EXHIBIT NO. 2

APPLICATION NO.

CD-63-03

INS Area VI

Smugglers <sup>INS</sup> Gulch Plan

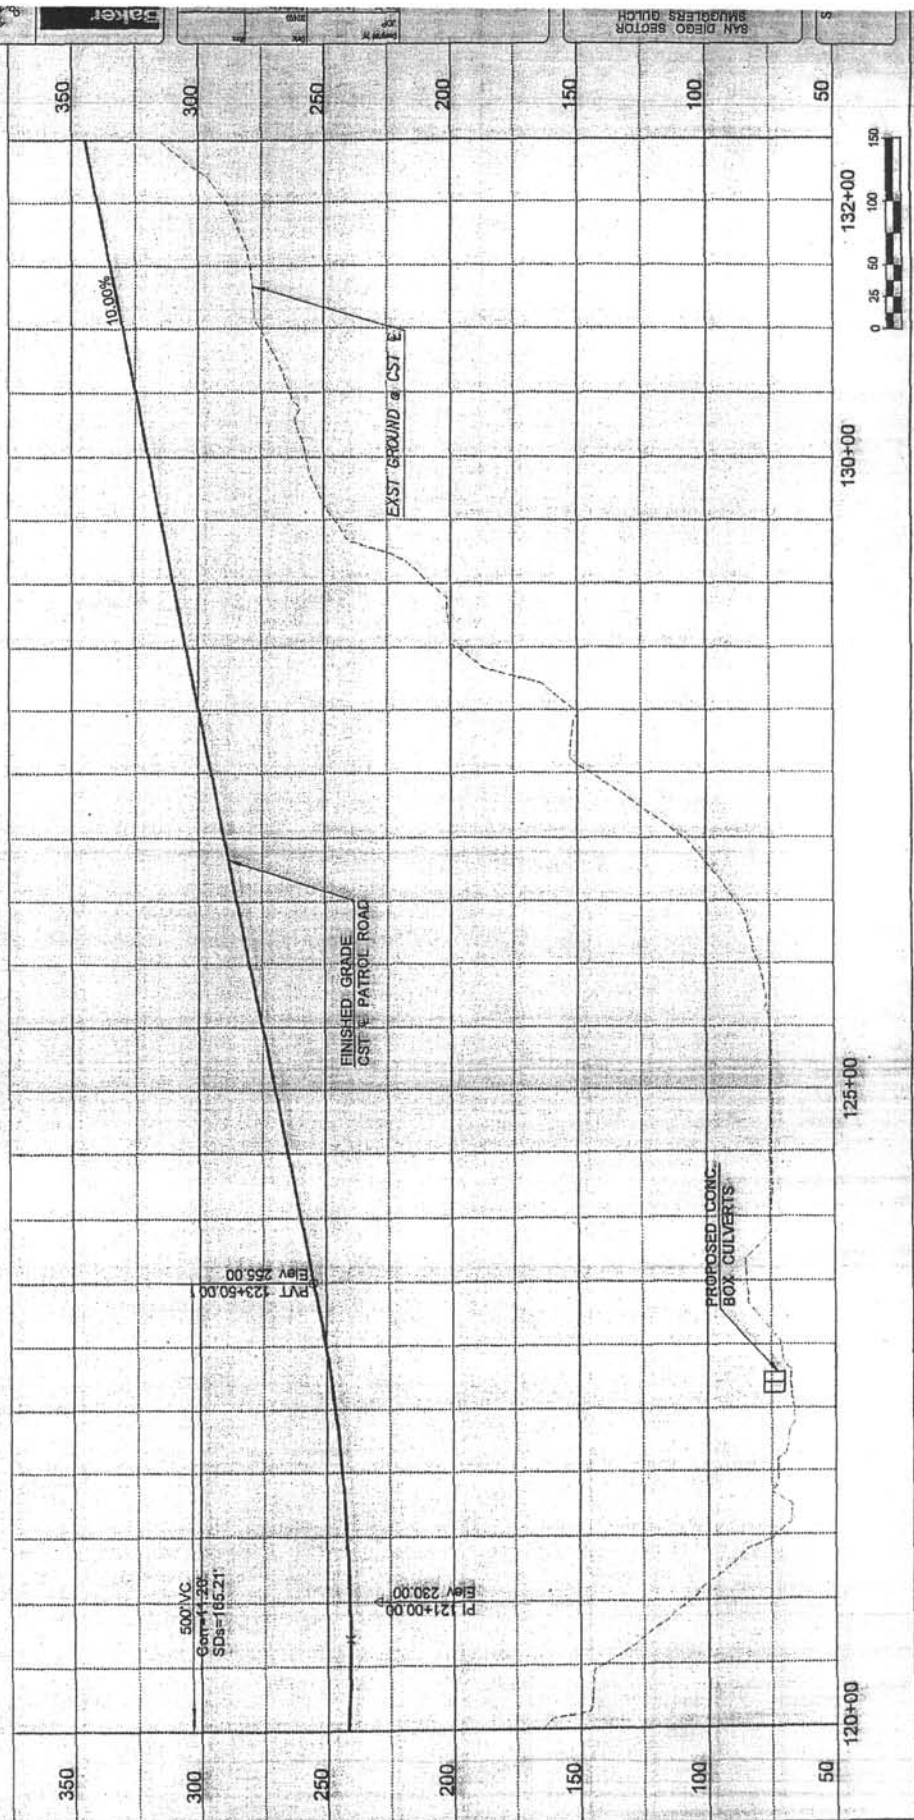
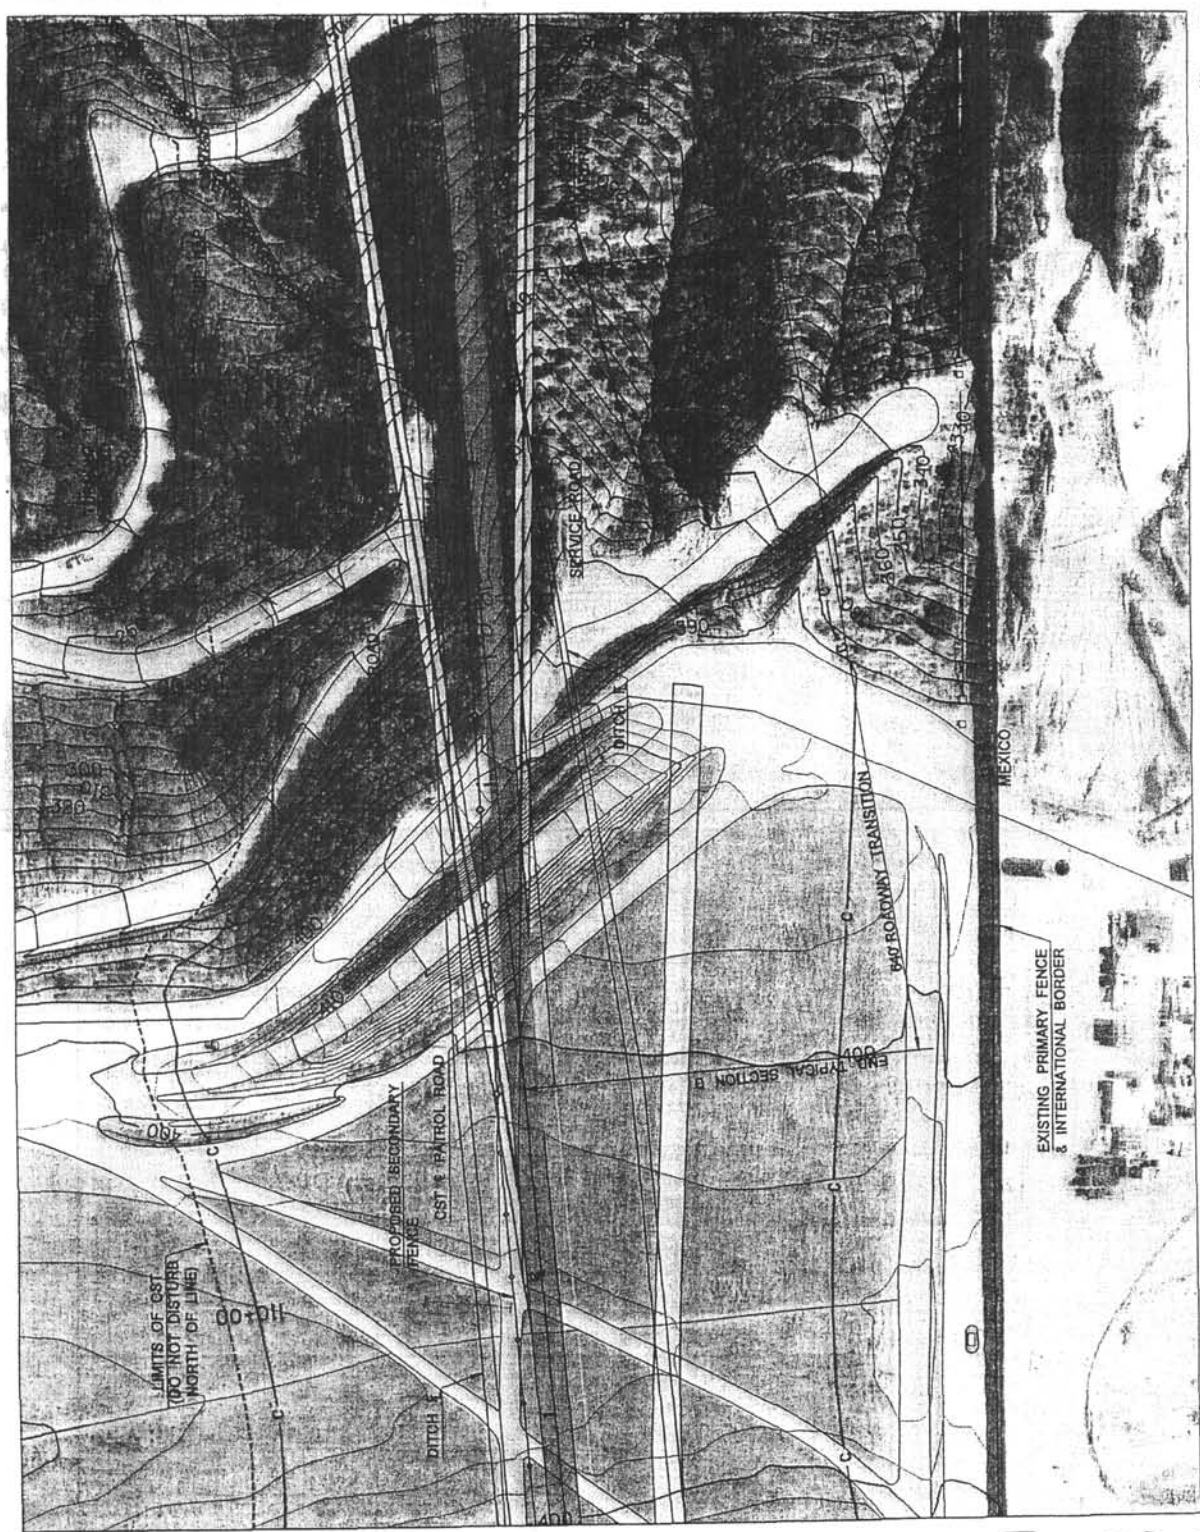
The Baker report contains provision for erosion control in two areas; source control on the earthen embankment and protection from accelerated channel flow from the 650 ft culvert. Permanent erosion control on the project will include a biodegradable geotextile, application of native vegetation seeds, terraces or benches on long slopes and sedimentation basins. Without more detailed plans and

specifications, and information on monitoring and maintenance, it is difficult to comment on the effectiveness of these measures for sediment control. We anticipate that there may be problems achieving vegetation establishment on the embankments due to the relatively harsh growing environment and soils, and that rill and gully development may be a problem. A particular problem is that if the geotextile biodegrades before vegetation becomes established, erosion potential on the embankment will almost double. Using the Baker report MUSLE model and a modified C value of 0.45 (no canopy cover, no geotextile) causes the average annual project sediment yield to rise from 796 tons per year to 1,493 tons. With regards to the energy dissipator at the downstream end of the culvert, there is a discrepancy between the velocity figure stated in the report (23 fps) and that used in the calculations for rip rap to protect the outfall (11.7 fps). Using the HEC-11 rip rap sizing equation the figure of 11.7 fps does give a mean diameter value of 0.88 ft, rounded up to 1 ft for safety. However, if the value used in the report is taken as correct, the required rock diameter rises to almost 7 ft. Likewise the length of channel armoring required is adequate assuming the appendix figures are used, but too small if the report figures are correct.

Given the uncertainty and potential for alternative interpretation of the results, we recommend that an independent party repeat the MUSLE analysis. The analysis should incorporate all project areas and should contain a range of assumptions based on more realistic erosion control scenarios. It would also be advisable to have a ground geomorphic assessment of the project site to qualitatively assess the potential for sediment to be delivered to the estuary, and the effect of the culvert on the channel downstream.
